WOOLLACOTT ARCHITECTS **GILMARTIN**
15a Parliament Hill London NW3 2SY
0207 431 9983 wgarchitects@mac.com
07933 672 917 woollacottgilmartin.com

**15a Parliament Hill
New House**
12.05.2016
**Proposed
Section: b/2**

P/1:50/202/b/2

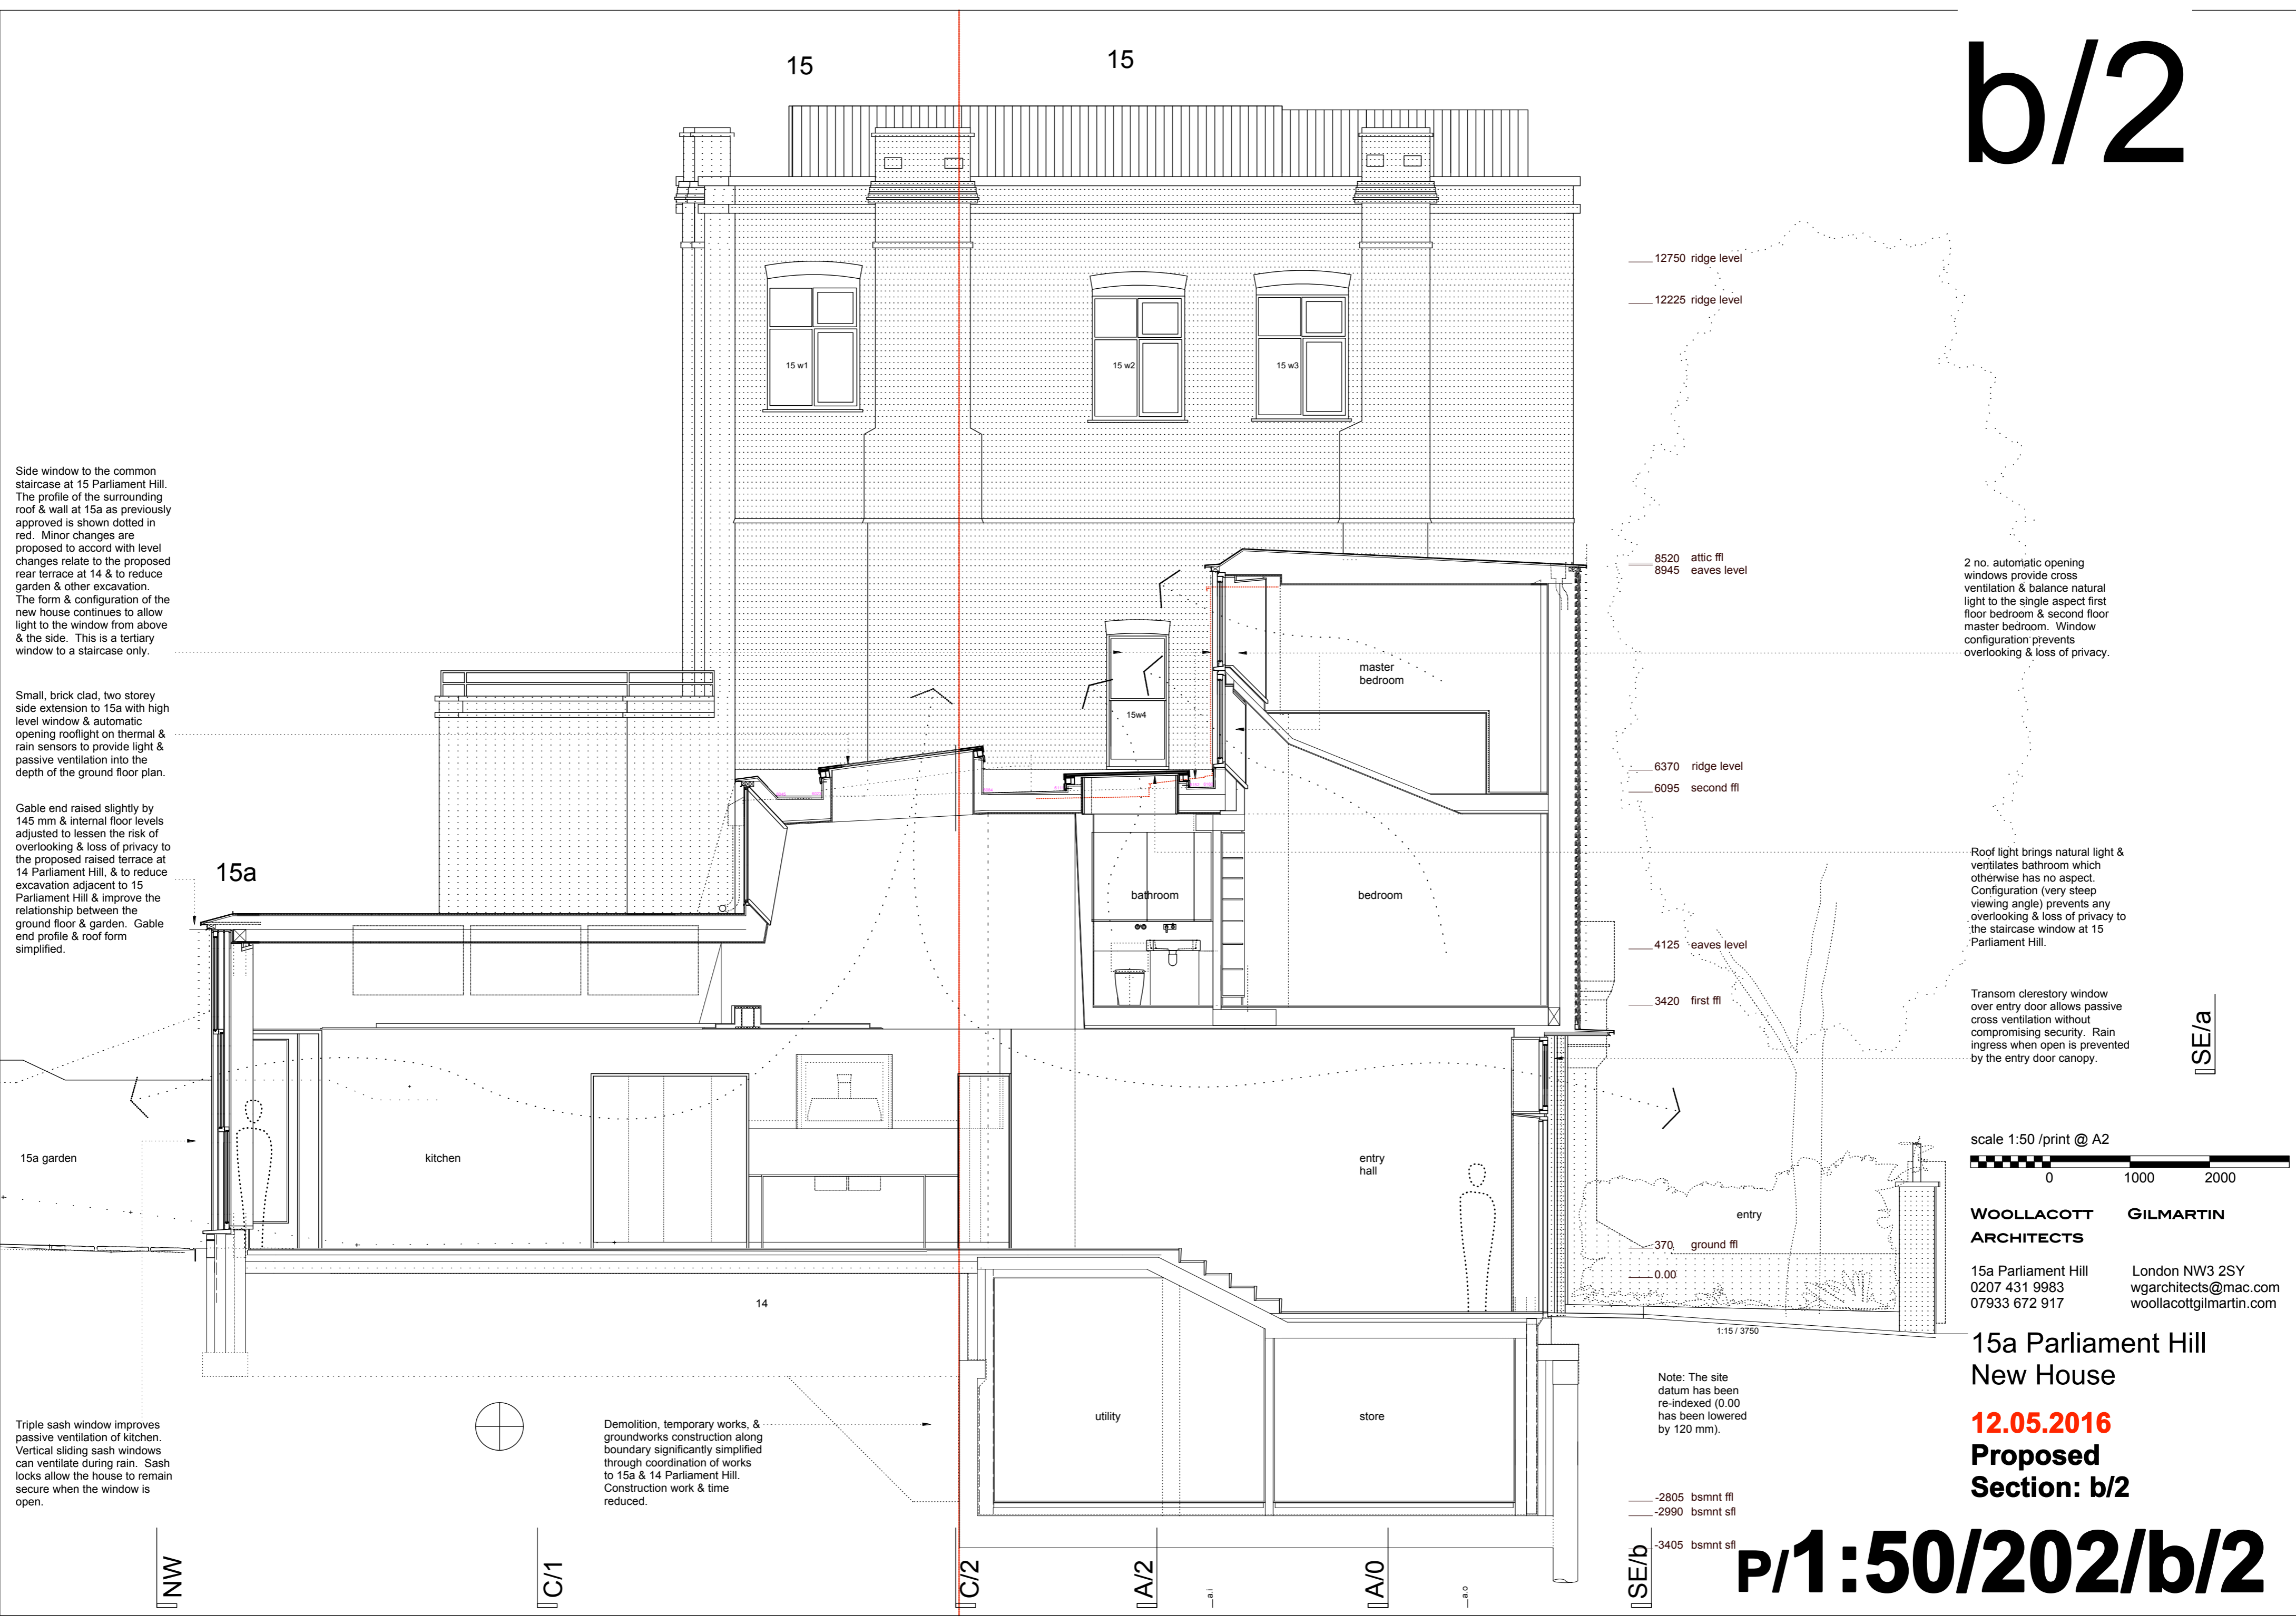
Side window to the common staircase at 15 Parliament Hill. The profile of the surrounding roof & wall at 15a as previously approved is shown dotted in red. Minor changes are proposed to accord with level changes relate to the proposed rear terrace at 14 & to reduce garden & other excavation. The form & configuration of the new house continues to allow light to the window from above & the side. This is a tertiary window to a staircase only.

Small, brick clad, two storey side extension to 15a with high level window & automatic opening rooflight on thermal & rain sensors to provide light & passive ventilation into the depth of the ground floor plan.

Gable end raised slightly by 145 mm & internal floor levels adjusted to lessen the risk of overlooking & loss of privacy to the proposed raised terrace at 14 Parliament Hill, & to reduce excavation adjacent to 15 Parliament Hill & improve the relationship between the ground floor & garden. Gable end profile & roof form simplified.

Triple sash window improves passive ventilation of kitchen. Vertical sliding sash windows can ventilate during rain. Sash locks allow the house to remain secure when the window is open.

Demolition, temporary works, & groundworks construction along boundary significantly simplified through coordination of works to 15a & 14 Parliament Hill. Construction work & time reduced.

2 no. automatic opening windows provide cross ventilation & balance natural light to the single aspect first floor bedroom & second floor master bedroom. Window configuration prevents overlooking & loss of privacy.

Roof light brings natural light & ventilates bathroom which otherwise has no aspect. Configuration (very steep viewing angle) prevents any overlooking & loss of privacy to the staircase window at 15 Parliament Hill.

Transom clerestory window over entry door allows passive cross ventilation without compromising security. Rain ingress when open is prevented by the entry door canopy.
